# CONSERVATION COMMISSION DETAILED AGENDA

Date: December 5, 2022

#### 1. 126 Lake Road – NOI – Raze and rebuild of a lakefront lot– DEP File #300-XXXX

## 126 Lake Road Site Photos

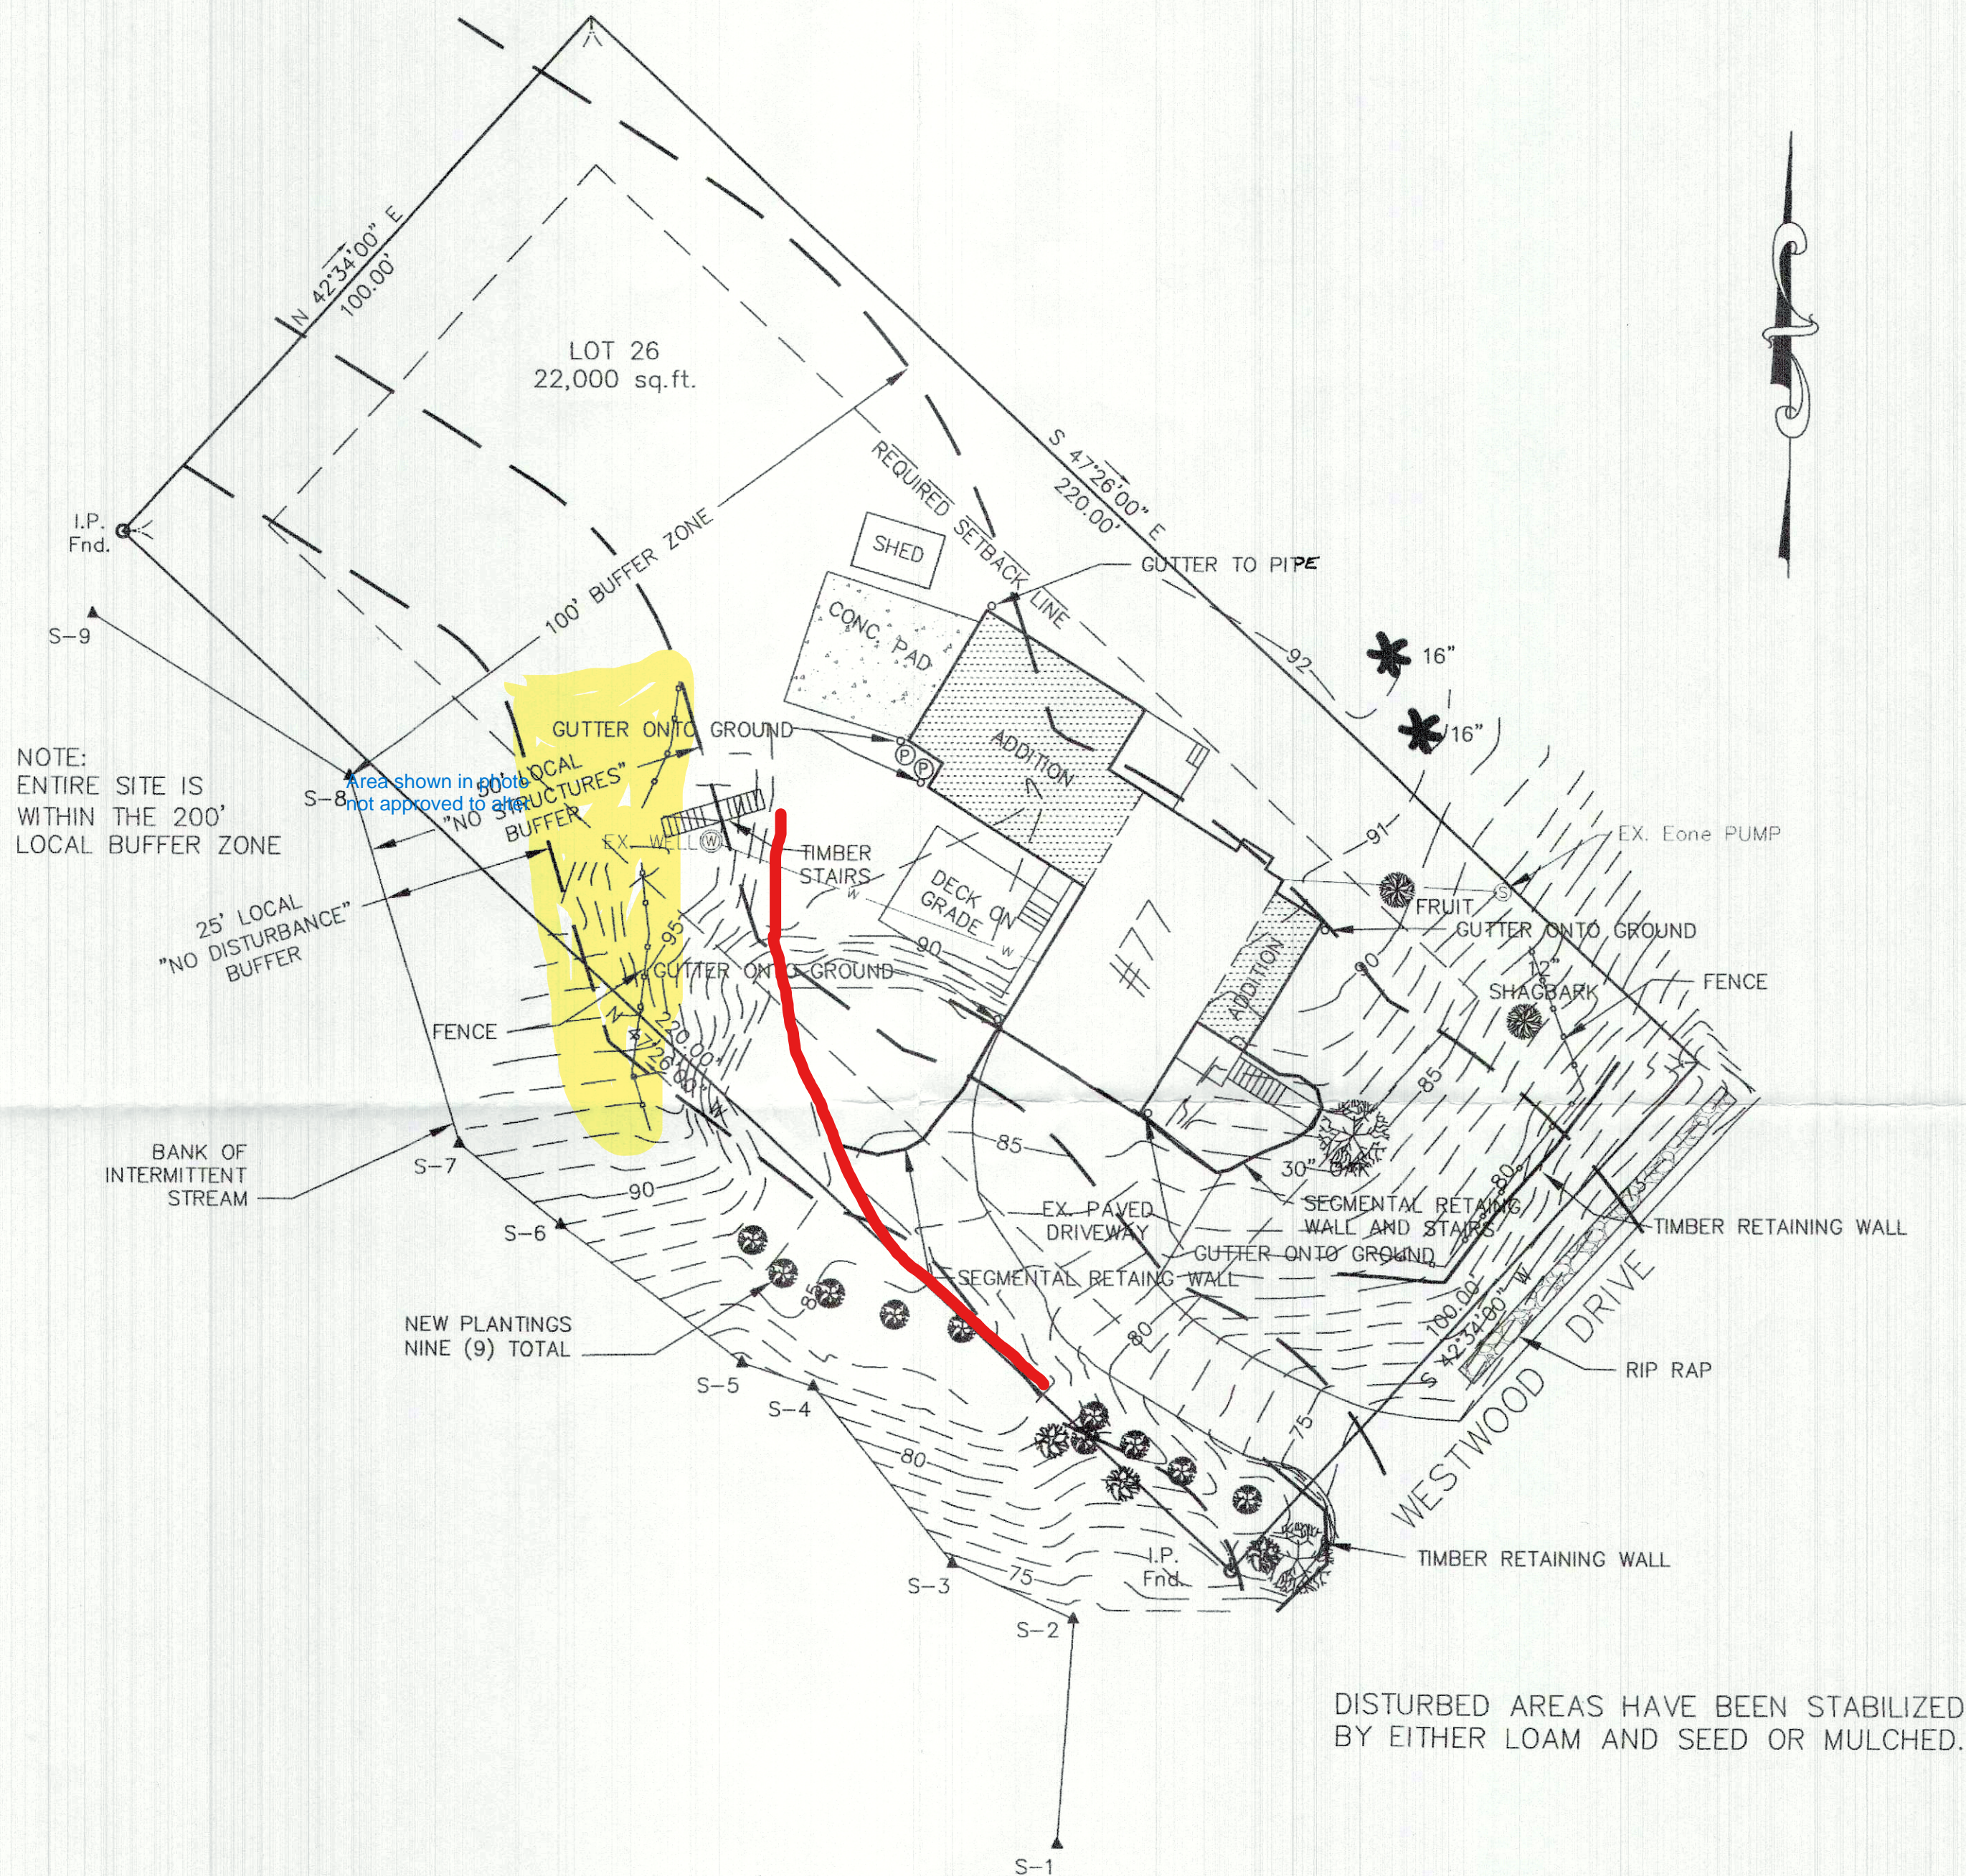
- Site visit performed. Revised plan received based on comments (see below)
  - Site contains Bank associated with Big Alum Pond and 2 isolated wetlands bisected by an existing driveway. Entire site is located within the 50' no build setback. No BLSF on site.

- New structure is within 50' no build setback. Alternative analysis must be shown that all alternatives explored before board can consider.
  - A waiver would be required. A waiver is required to be requested. Waiver must be requested and outline mitigation provided. Mitigation provided on revised plan.

- All options to meet the SWB standards must be explored and documented in able to be eligible for a waiver.
  - A breakdown of the existing structure and new structure within 25' and 50' of resource areas needs to be shown. – on revised plans

- Added construction sequence notes
  - Options discussed to remove full foundation to minimize disturbance. House was shifted outside of the 25' no disturb. Option discussed to include a partial foundation for mechanical room and to have the rest of the house on helical pilings to minimize disturbance. Has this been explored? Patio should be shown as pervious.

- Revised plan received based on site visit for preliminary review. Revisions include:
    - Added a 25' buffer zone to the wetlands
    - Propose to remove shed and added mitigation plantings there (Red maple and winterberry)

- Rotated house and shifted it outside the 25' wetland buffer. The house is now located farther than the existing house and I have updated the zoning setbacks table. The proposed house is located within the building setback lines.

- Added a proposed patio at rear of house
    - Added proposed roof leader drywells to infiltrate roof runoff
    - Trim multiflora rose along west side of driveway

- Two dead hemlock trees on west side of house to be removed (cut flush to grade)

- Tie in sewer line from new house to existing pump chamber
  - Show connection to existing well
  - Shifted silt fence around east side of house to preserve existing vegetation

- Small clump of birches near the shed are to be cut which are in conflict with overhead electric wires
  - Added a buffer zone impervious calculation table
